APPLICATION FOR
AMENDMENT OF PLAN UNDER SECTION 12A OF
THE TOWN PLANNING ORDINANCE
(CAP.131)

For Official Use Only 請勿填寫此欄	Application No. 申請編號	Y/YL-MP/6
	Date Received 收到日期	15 SEP 2021

**Rezoning from "Residential (Group D)" to "Residential (Group C) 1" Zone
For a Proposed Residential Development at Various Lots in D.D. 104 and
the Adjoining Government Land in Yuen Long, N.T.
S12A Amendment of Plan Application**

**Rezoning from "Residential (Group D)" to "Residential (Group C) 1" Zone
For a Proposed Residential Development at Various Lots in D.D. 104 and
the Adjoining Government Land in Yuen Long, N.T.
S12A Amendment of Plan Application
TPB Ref. Y/YL-MP/6**

Figure 1. Flocks of wild ducks (and also other waterbirds such as ardeids) utilising the NTMDC section between Y/YL-MP/6 and Y/YL-MP/8; observed in mid-November 2022.

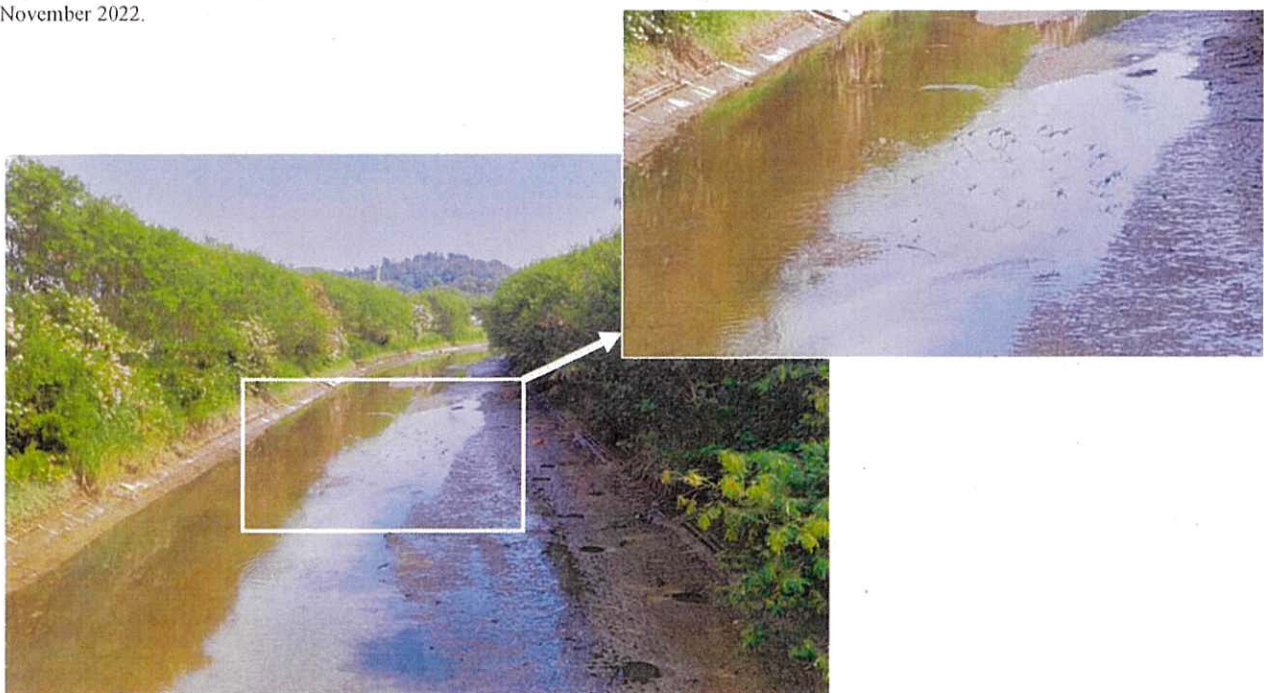
3. We should have in our previous submissions shown to the Board that the Ngau Tam Mei Drainage Channel (NTMDC) section adjacent to the application sites **Y/YL-MP/6** and **Y/YL-MP/8** was inhabited by many wetland birds, including wild ducks that are highly sensitive to human disturbance, and this previous observation was made in December 2021 (see Figure 1 of **Appendix A, Annex 1**). In our recent visits in mid-November 2022, we again observed flocks of wild ducks (and many other waterbird species such as ardeids) in this channel section (between **Y/YL-MP/6** and **Y/YL-MP/8**; see **Figure 1**), with some individuals scattered in the section next to **Y/YL-MP/7**. As observed, they are highly sensitive to approaching human (**Figure 2**; see also Figure 5 of **Appendix A, Annex 1**). In addition, we also observed **Black-faced Spoonbill** individuals, which is a wetland bird species considered to be **Globally Endangered¹**, actively foraging in the NTMDC section next to both **Y/YL-MP/6** and

Figure 3. Cont'd.

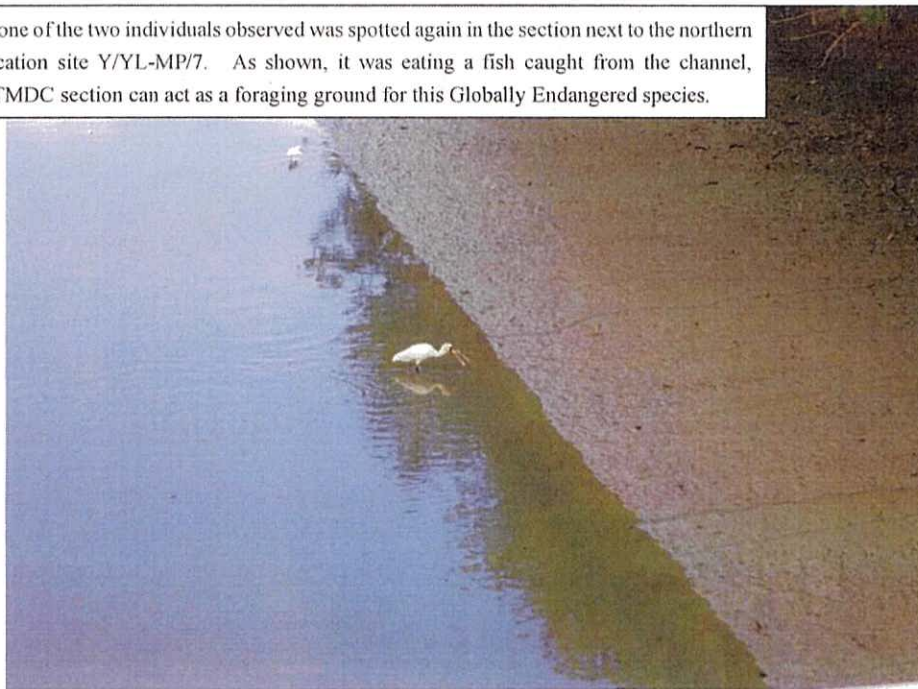
Y/YL-MP/7 in mid-November 2022 (see Figure 3). Locations of our recent sightings are shown in Figure 4.

On 17 Nov 2022, one of the two individuals observed was spotted again in the section next to the northern part of the application site Y/YL-MP/7. As shown, it was eating a fish caught from the channel, indicating this NTMDC section can act as a foraging ground for this Globally Endangered species.

Figure 5. Responses of wild ducks and other waterbirds to the approaching photographer.

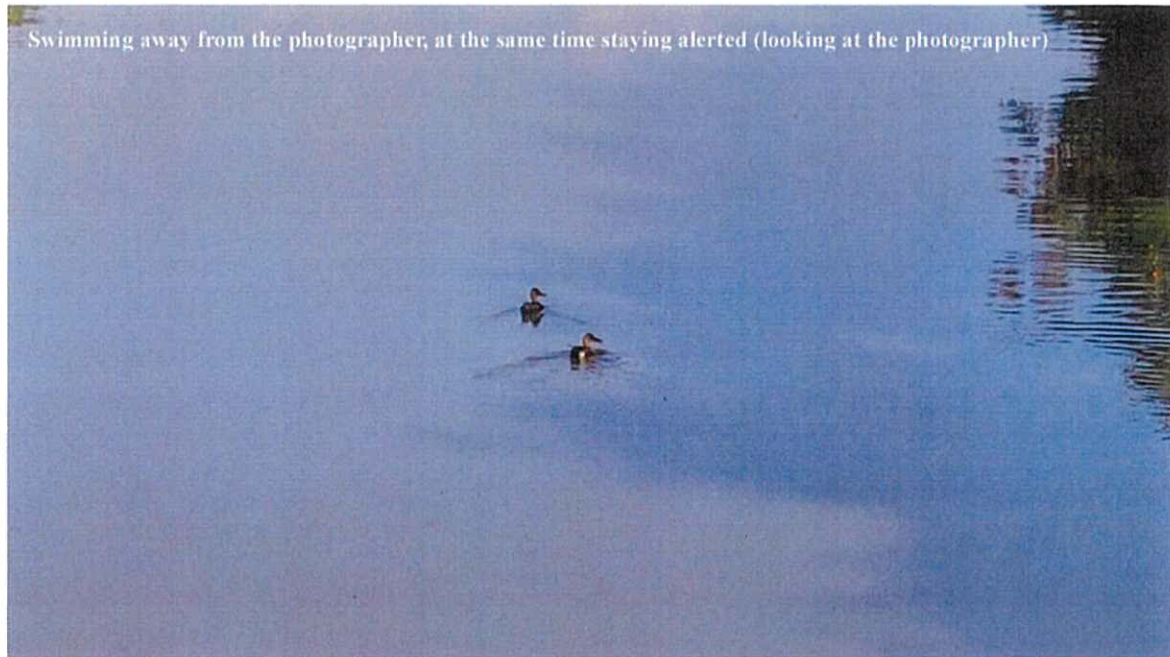
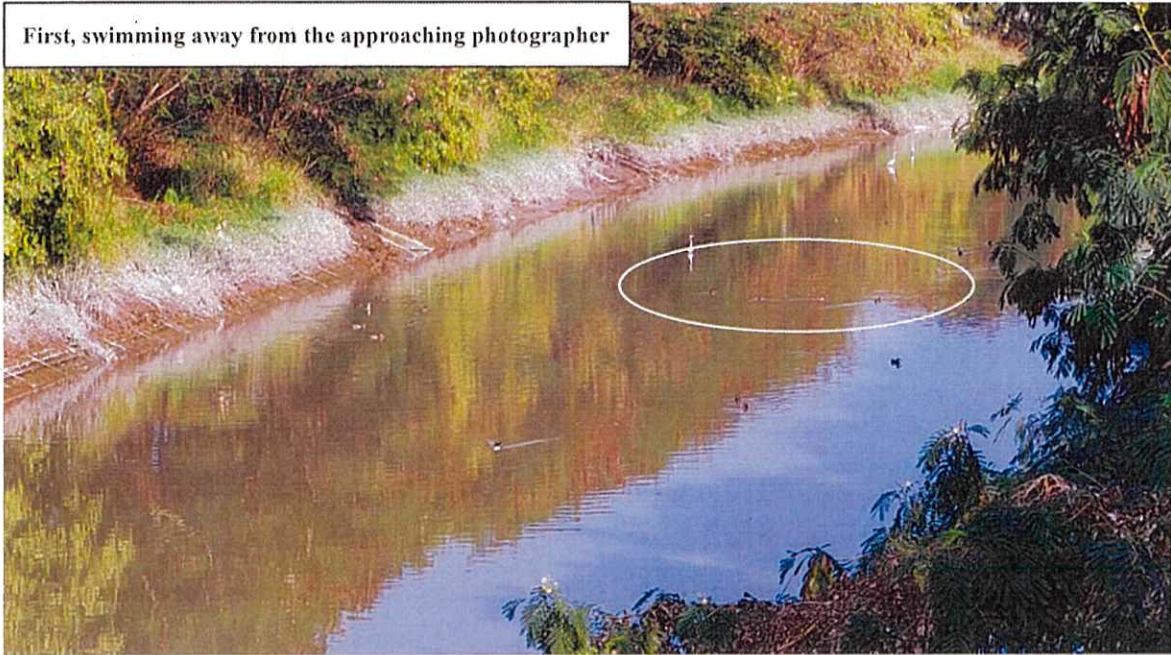
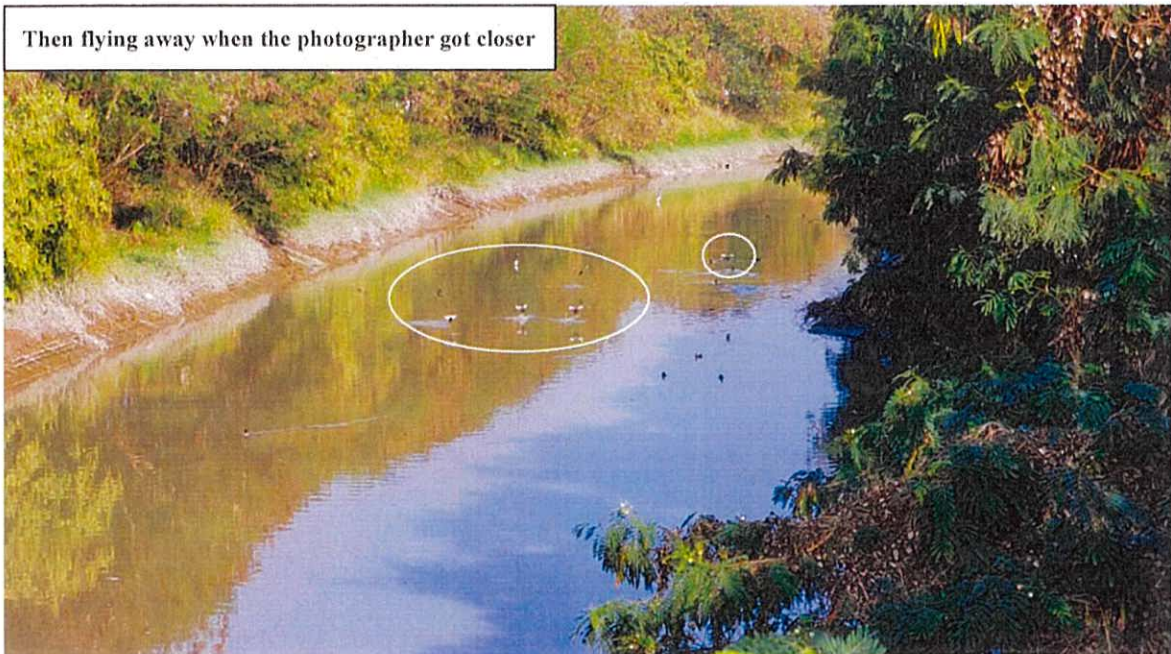
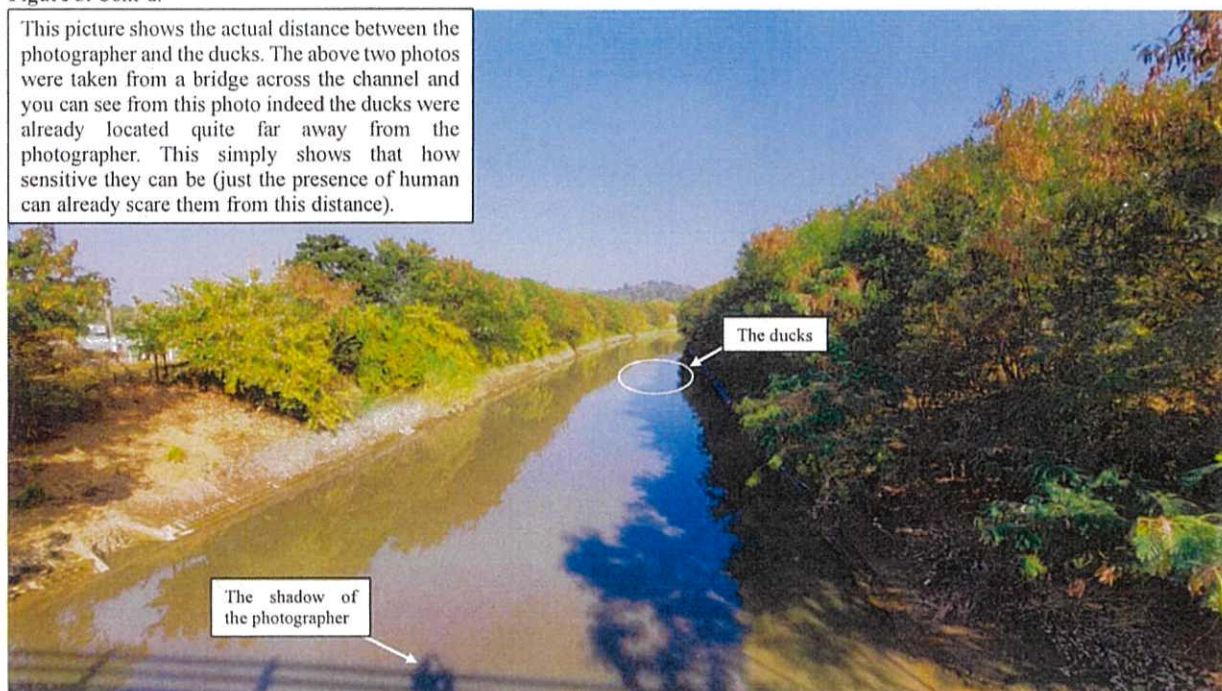
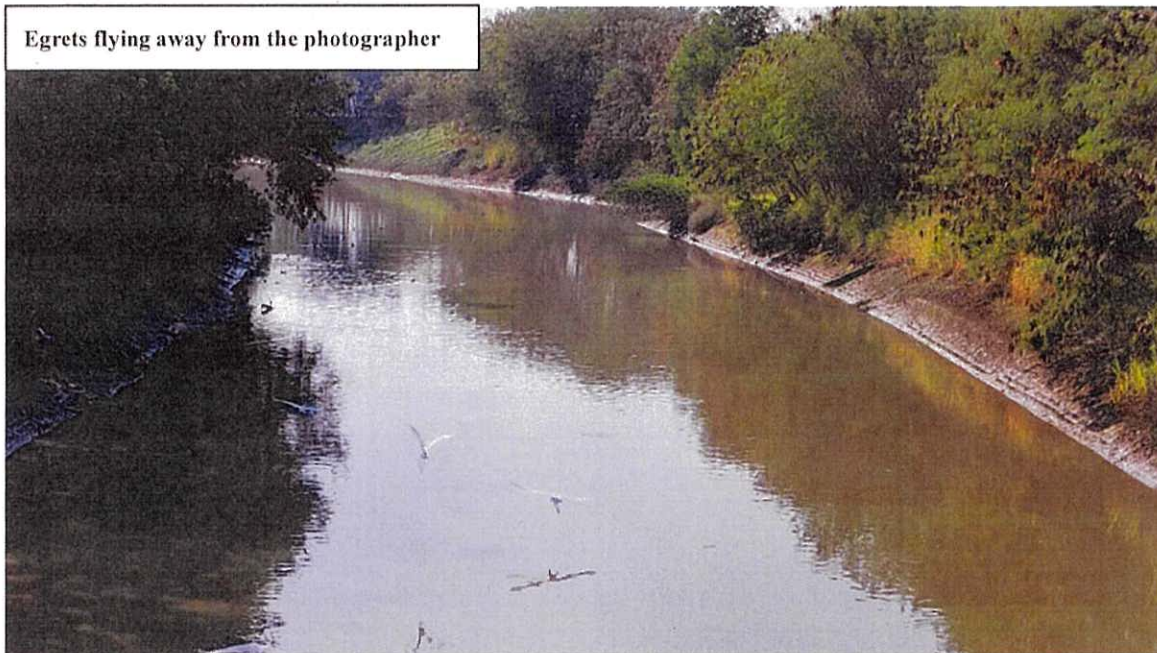
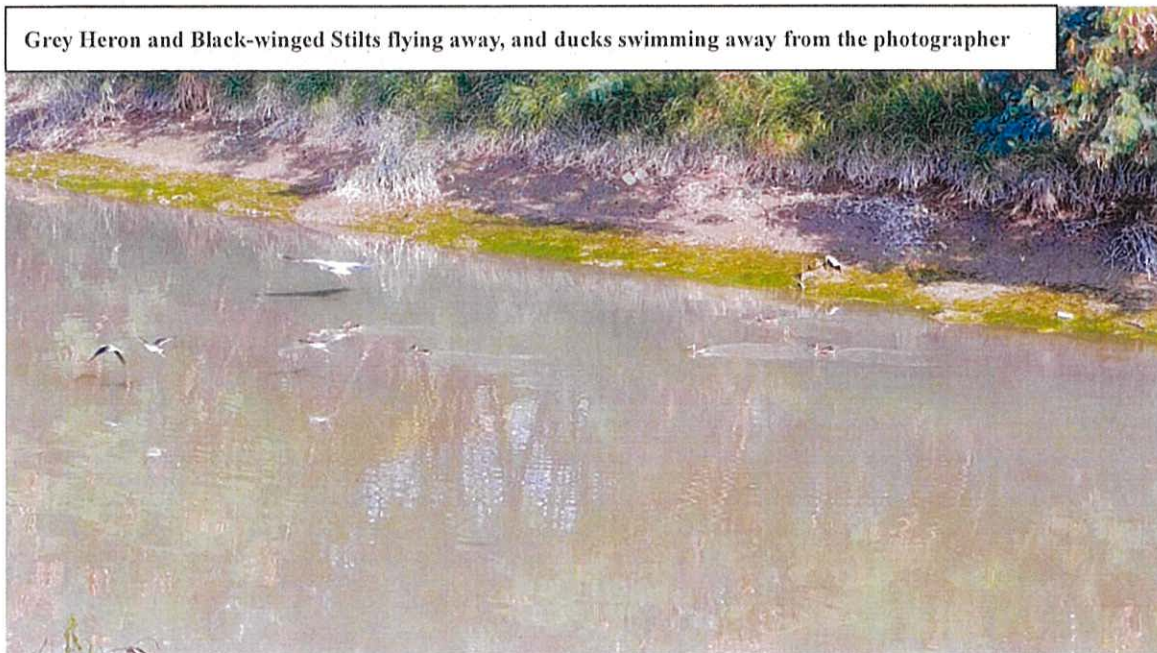
8. Wild ducks are usually highly sensitive to human disturbance. A study conducted in North America targeting wintering ducks (including the two species we observed) has indicated that nearly 80% of the studied individuals responded to the source of disturbance from a distance ranging between 51 – 100 m (more than 70% of them swam or flew away)¹. We could see similar behaviors during our visits; we observed that individuals of wild ducks simply swam or even flew away when the photographer approached them or when they could see the approaching photographer (see **Figure 5**), and they also responded to other human activities along the channel as well. Thus, the presence of a moderate number of wild ducks in this channel section clearly reflect that the existing disturbance level in the locality of concern is generally low (please also refer to some photos in Figure 3 of **Appendix 1** which show the areas surrounding the channel (e.g., Kam Pok Road, Yau Pok Road and associated cycle track and pedestrian road)). Also, in Hong Kong, wild ducks are usually restricted to wetlands in the northwestern New Territories area (i.e., it is not easy to see a wild duck in other parts of Hong Kong). Our observations reflect that the NTMDC section next to the application site is simply, and already, part of the Deep Bay wetland system, with considerable connection with the Mai Po Nature Reserve. **We urge the Board and relevant authorities to seriously consider whether the habitat quality of this channel section would still remain the same when 3,090 flats (including 10 high-rise blocks ranging from 16 to 23 storeys and several blocks from 3 to 5 storeys) are built next to it** (please also see Figure 4 in **Appendix 1**).

Figure 1. Distance between the application site and WCA.

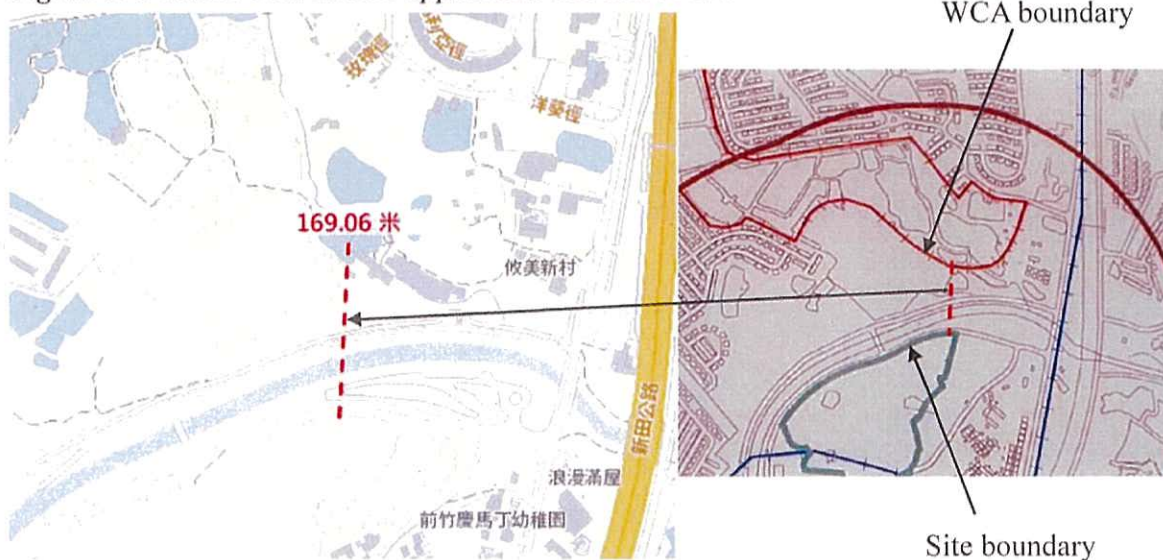
5. While we cannot quite understand how the application site can be considered to be ‘close to’ the future ‘development node of the NOL at NTM’, we would like to again point out that the site is now located less than 170 m from the WCA and next to wetland habitat of moderate ecological importance (i.e., NTMDC; see later explanation). Also, we would like the Board to look at the photomontage extracted from the gist and reproduced in **Figure 4** of this letter, as well as the on-site conditions as shown in **Figure 3**. We urge the Board to consider whether the proposed development, with 10 high-rise blocks ranging from 16 to 23 storeys and several blocks from 3 to 5 storeys, can be considered to be compatible (or ‘not incompatible’) with the existing surroundings, and whether the addition of trees or plantings could help to integrate the proposed high-rise blocks (i.e., max. 23 storeys) with the surroundings.

Figure 3. On-site photos taken in October 2021.

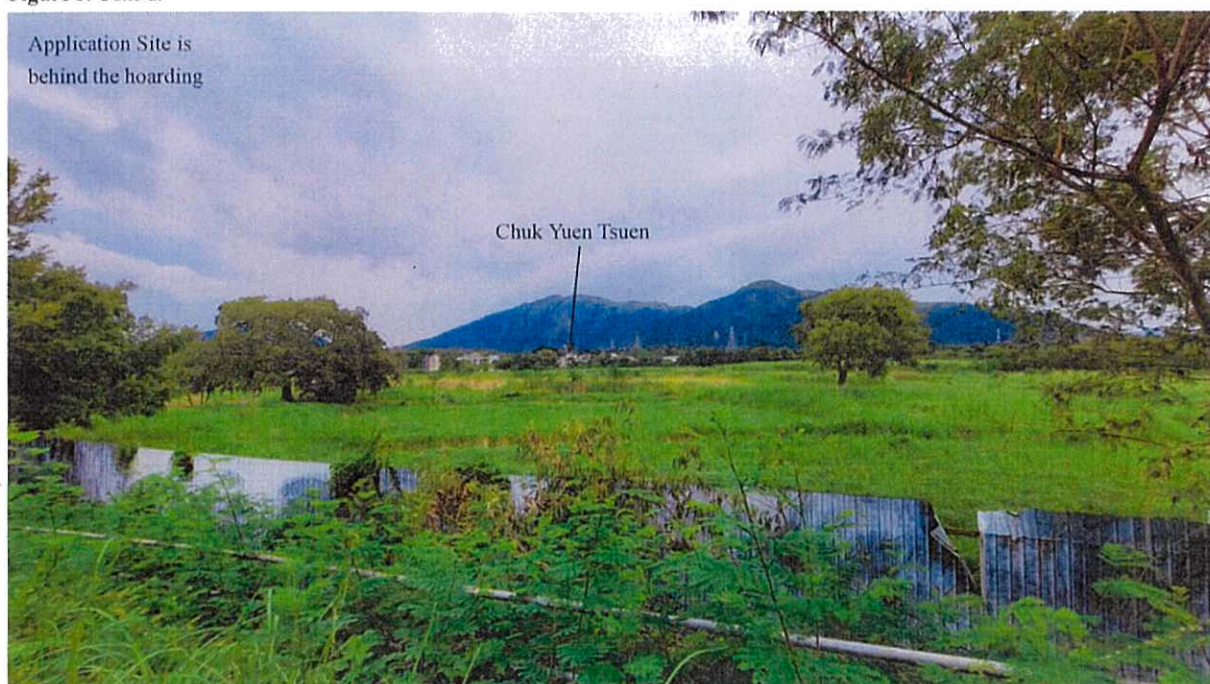
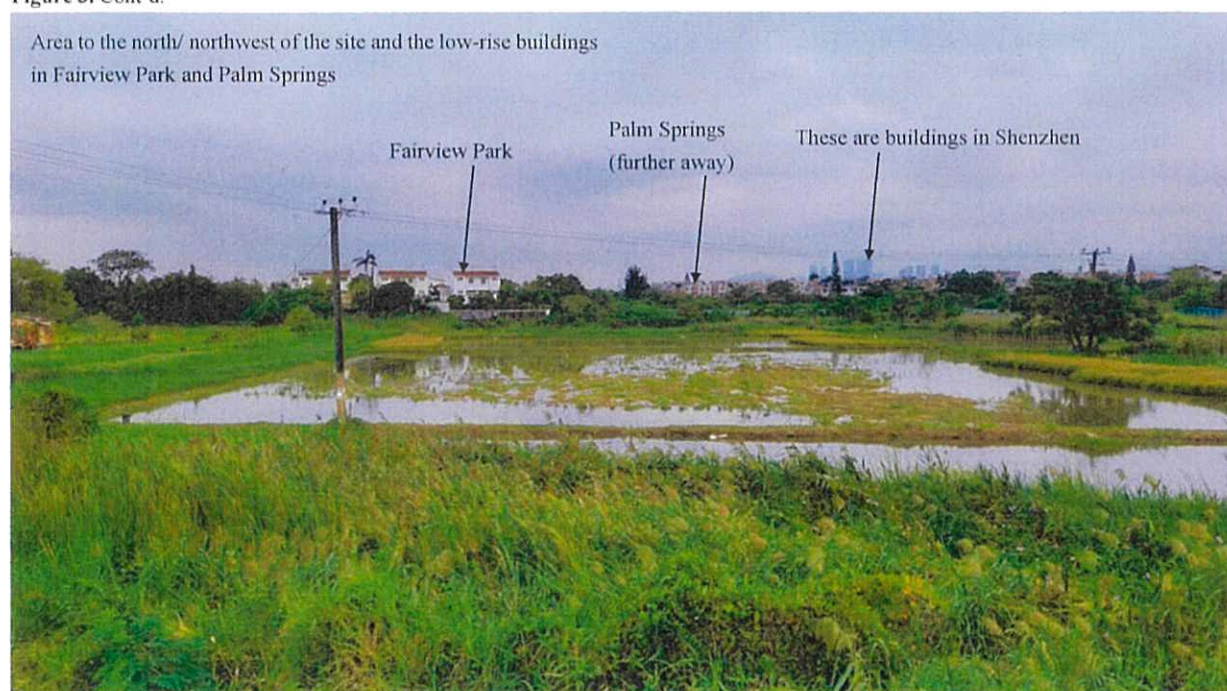
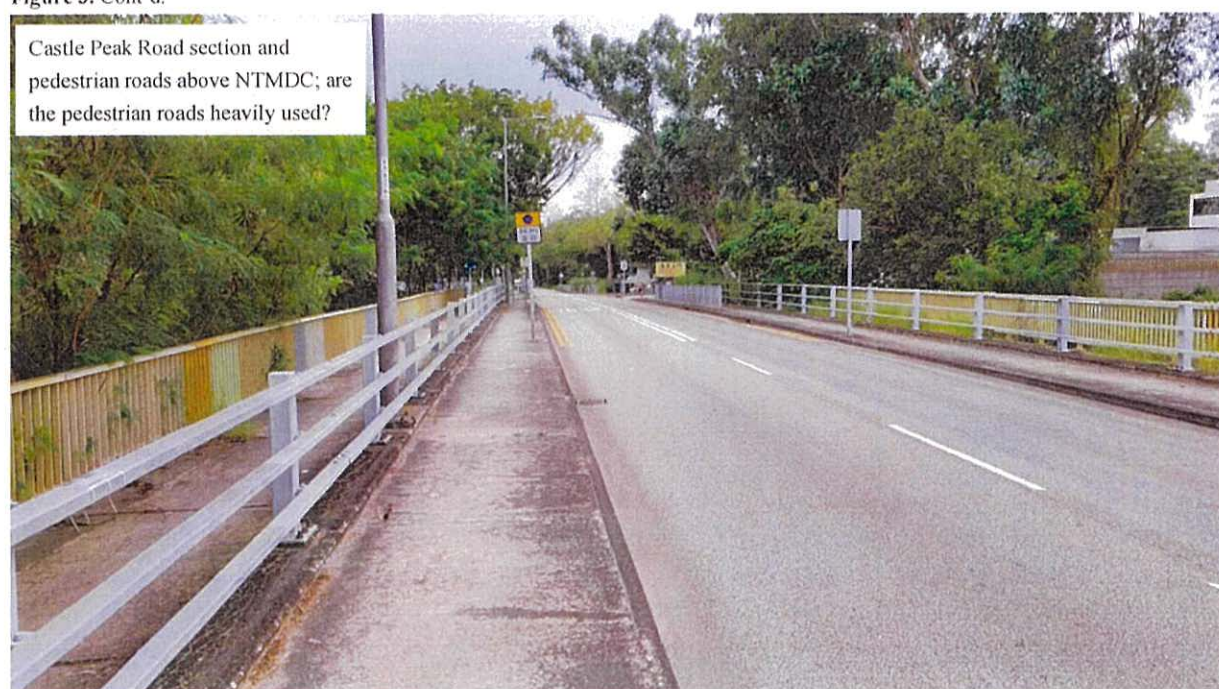
disturbance (e.g., 4, 5) (see also a photo in **Figure 3**). While one of the key concerns would be how long the disturbance distance is, the approved Environmental Impact Assessment (EIA) for the Sheung Shui to Lok Ma Chau Spur Line has provided that the exclusion distance (where a species is precluded from using the area because of the impacts from the station and railway) of BFS is 100 m, and the maximum distance of reduced density ranges from 150 to 200 m⁶; also, this approved EIA has considered the overall disturbance sensitivity of BFS to be ‘high’⁶. In addition to this EIA, there is also a scientific study (published in 2015) examining the response of wintering BFS to disturbance⁷; this study states that:

Although the vegetation along Kam Pok Road seems to be thicker, NTMDC can still be seen from the road.
